*PLANS FOR THE CONSTRUCTION OF
SEDIMENT REMOVAL
FOR
VITRUVIAN PARK
TOWN OF ADDISON, TEXAS
PUBLIC WORKS #19-77*

VITRUVIAN PARK
 DREDGING
 TOWN OF ADDISON
 DALLAS COUNTY, TEXAS

revisions	date
1 ADDENDUM 3	2/20/2019

GROTTO CROSS SECTIONS				
design	drawn	checked	scale	date
NDM	NDM	NDM	NDM	2/20/19

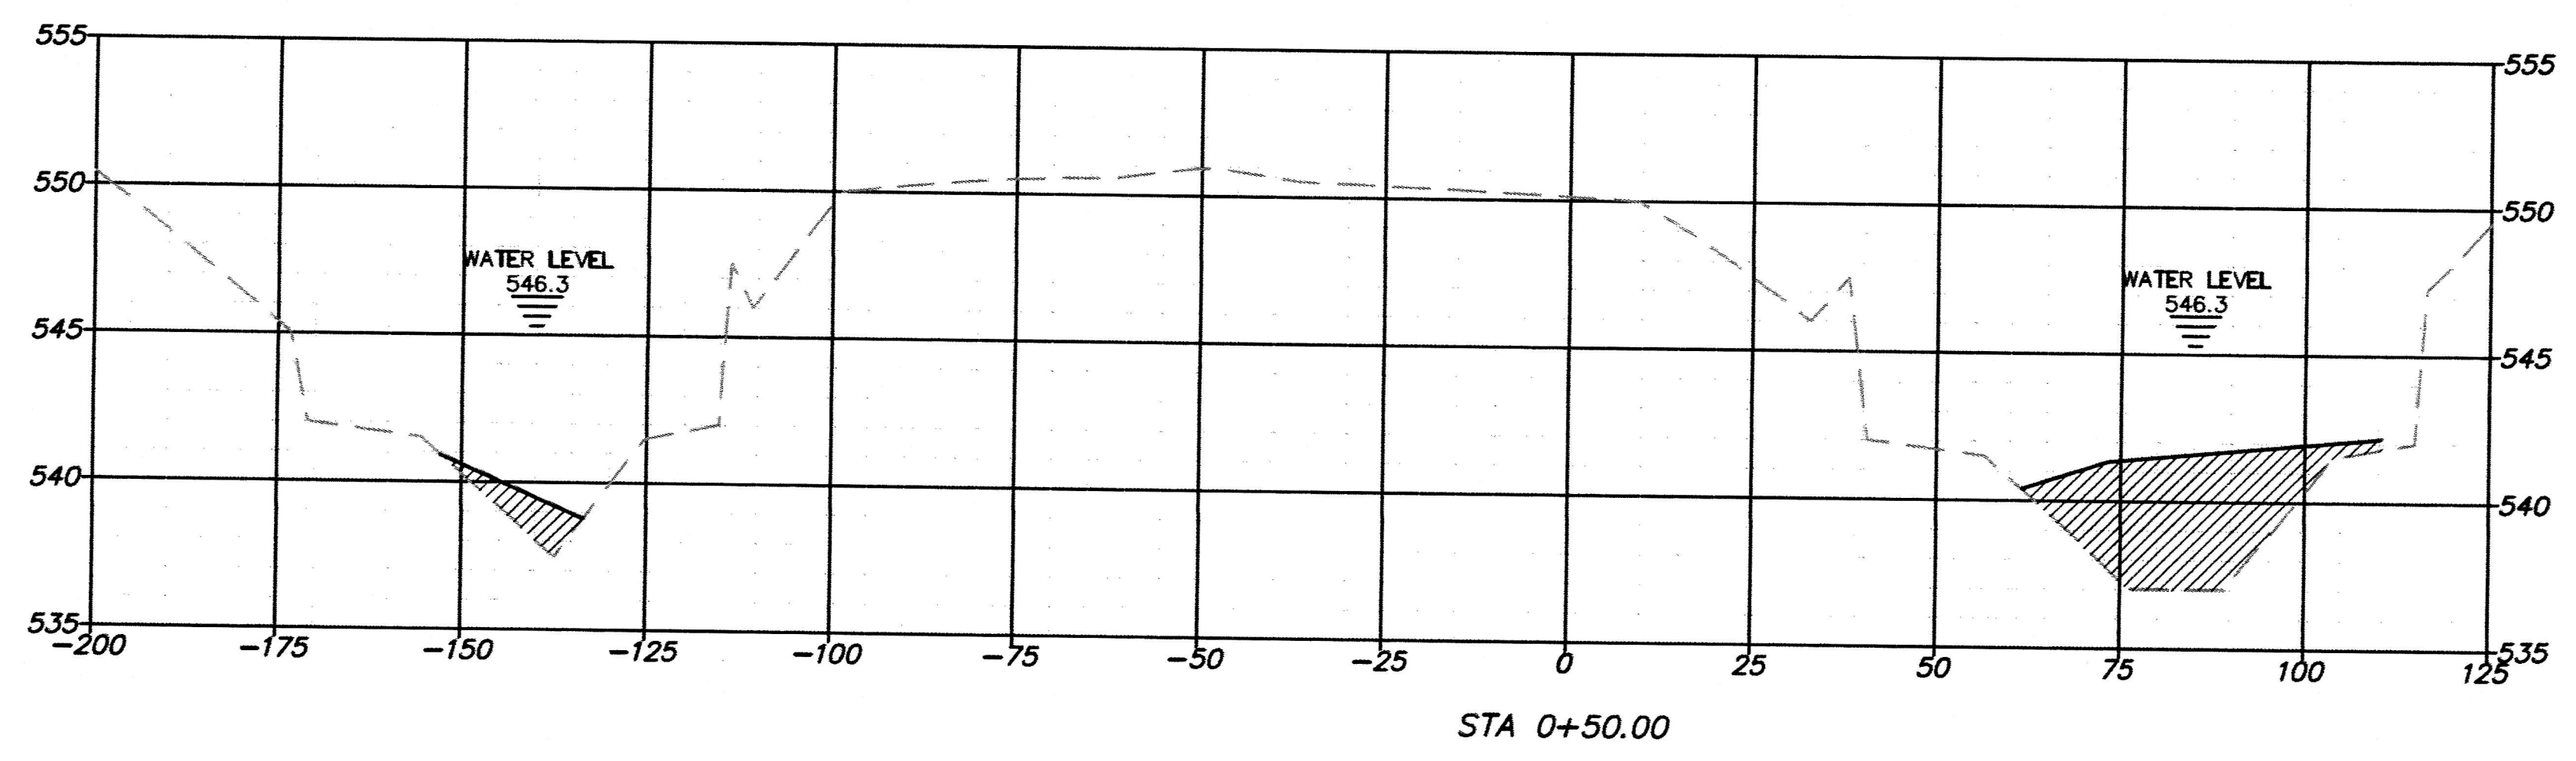
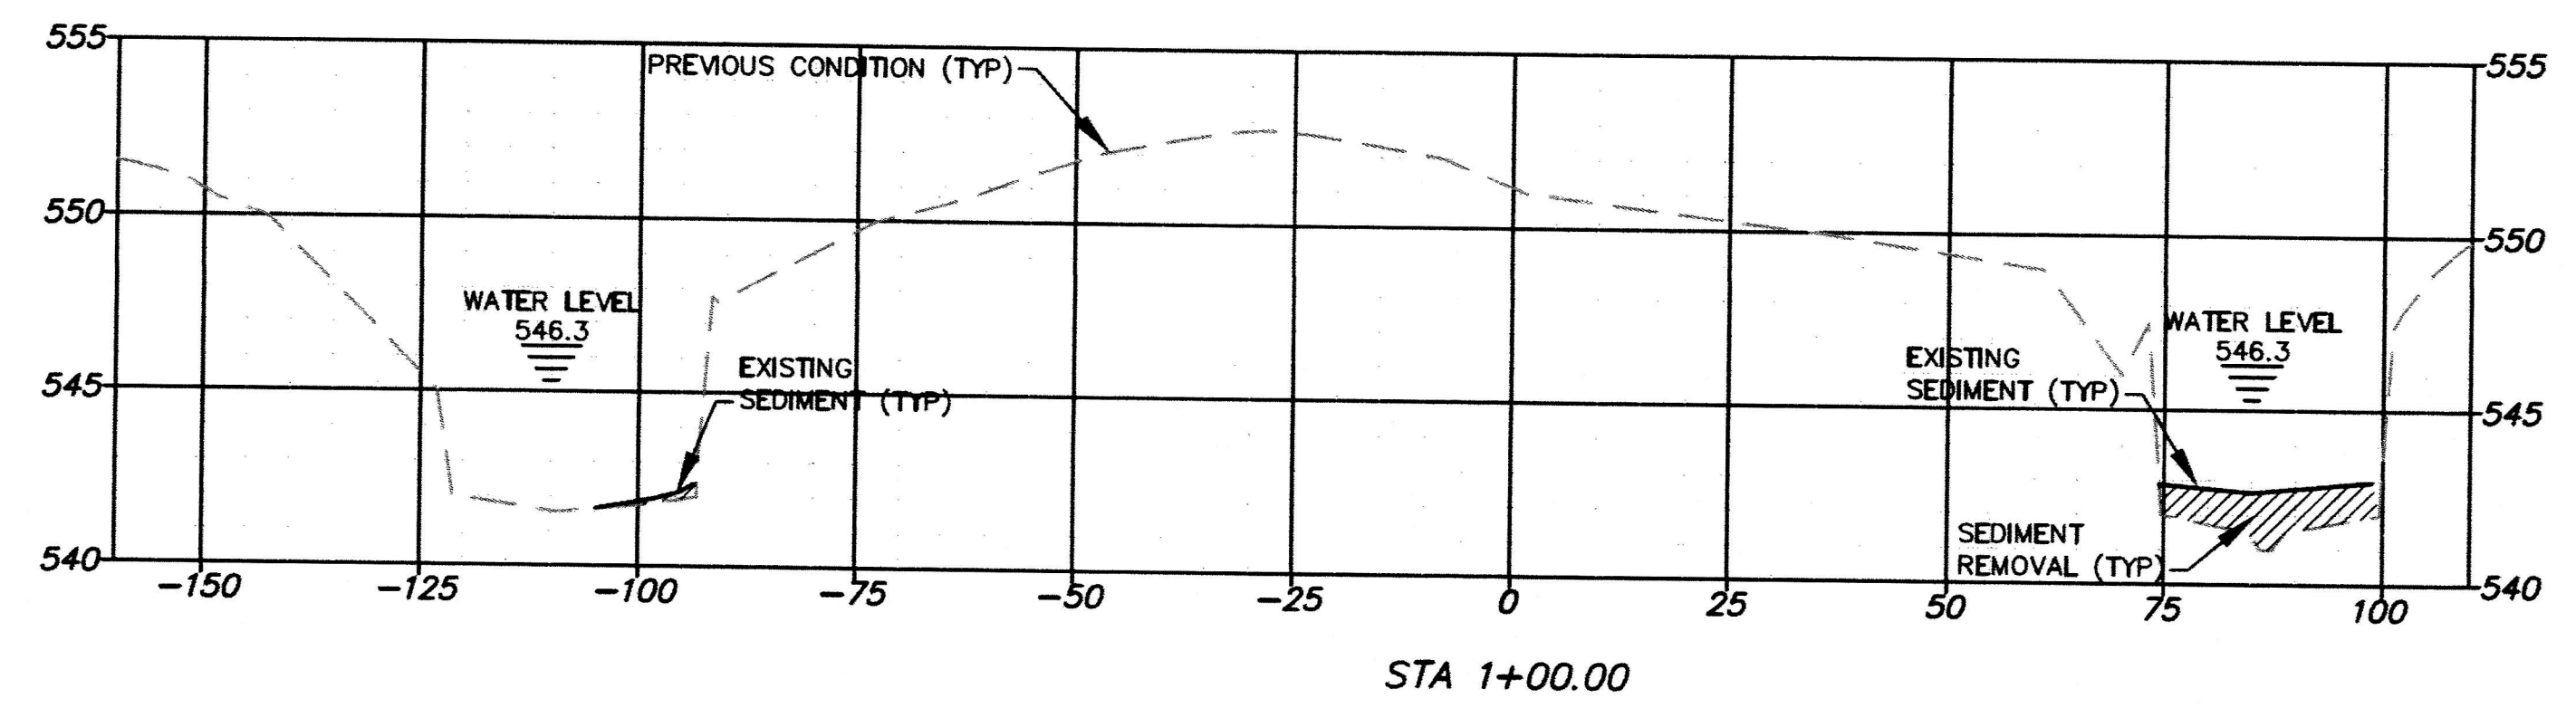
▲ WATER SURFACE ADDED BASED ON SURVEY OF 2/18/2019.
